Agenda Item # 4

SUB-003593-2025

Davis Place Subdivision

- Subdivision approval to create two (2) legal lots of record from one (1) existing metes-and-bounds parcel.

DETAIL SITE PLAN

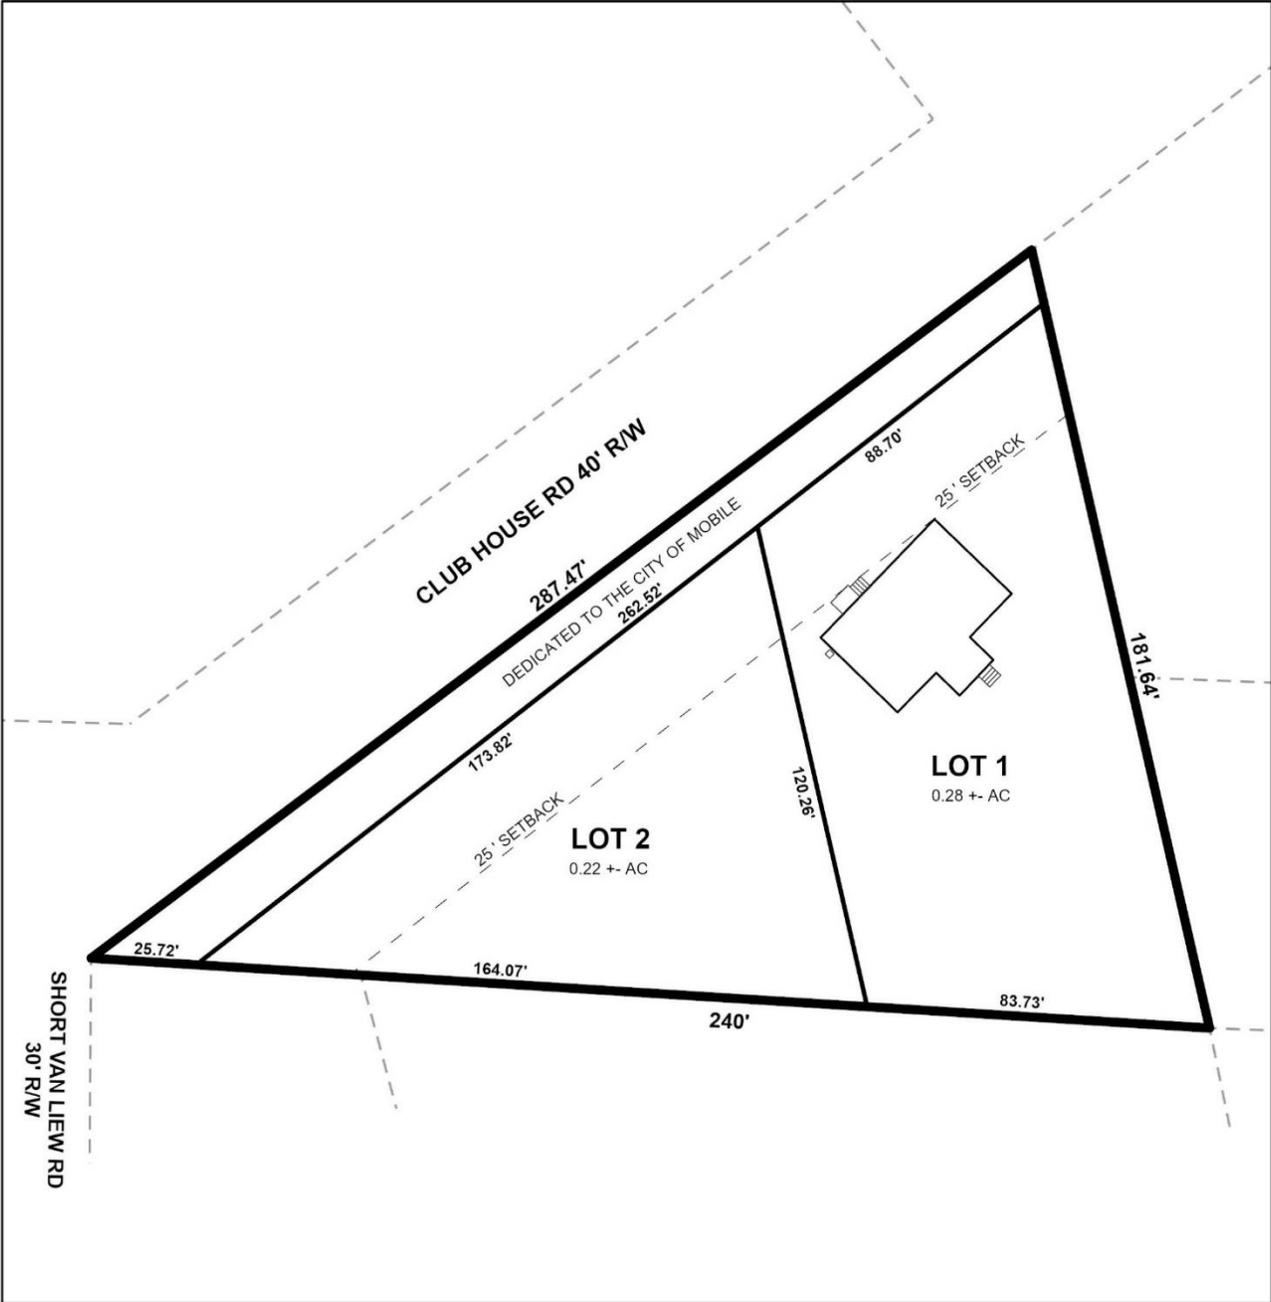
- B. Show and label the tie between the POB and the new NE corner of LOT 1 and correct the wording in the written legal description. Is this point the POC or POB? Can this point be described as the NW corner of LOT 1 Caster Place?

- C. Label the dedicated ROW as "Hereby dedicated to the City of Mobile" and include the amount of dedication in SF and Acres.
- D. Clarify the 195' dimension on the east property line. Does it begin at the POC or POB?

- E. Add the following note - As shown on the 1984 aerial photo LOTS 1 and 2 will share the 2,000 sf of historical credit of existing (1984) impervious area towards stormwater detention requirement per Mobile City Code, Chapter 17, Storm Water Management and Flood Control) and share the 4,000 SF credit provided to the original SF residential lot as follows: LOT 1 – 3,000 sf and LOT 2 – 3,000 sf. Stormwater detention will be required for any additional impervious area that exceeds the allowable credit for that LOT.

The property has frontage on Club House Road, which is designated as a Major Collector Street on the Major Street Plan, with a planned 50-foot-wide right-of-way along this segment. The existing right-of-way along the site frontage is 40 feet; therefore, dedication sufficient to provide a minimum of 25 feet from the centerline of Club House Road is required. The preliminary plat indicates that dedication to provide 30 feet from the centerline is proposed. If approved, the Final Plat should be revised to reflect and label the total right-of-way width of Club House Road after any required dedication.

The preliminary plat depicts a 25-foot minimum front yard setback line along Club House Road, measured from the proposed right-of-way line. This setback should be retained on the Final Plat, if approved.

- 1) Dedication sufficient to provide a minimum of 25 feet from the centerline of Club House Road;
- 2) Revision of the plat to label the right-of-way width of Club House Road after any required dedication;
- 3) Retention of the 25-foot minimum front yard setback line along Club House Road, as measured from any required dedication;
- 4) Retention of the lot size labels in both square feet and acres on the Final Plat, adjusted for any required dedication, or the provision of a table on the Final Plat with the same information;
- 5) Compliance with all Engineering comments noted in the staff report;
- 6) Placement of a note on the Final Plat stating the Traffic Engineering comments noted in the staff report;
- 7) Compliance with all Urban Forestry comments noted in the staff report; and
- 8) Compliance with all Fire Department comments noted in the staff report.
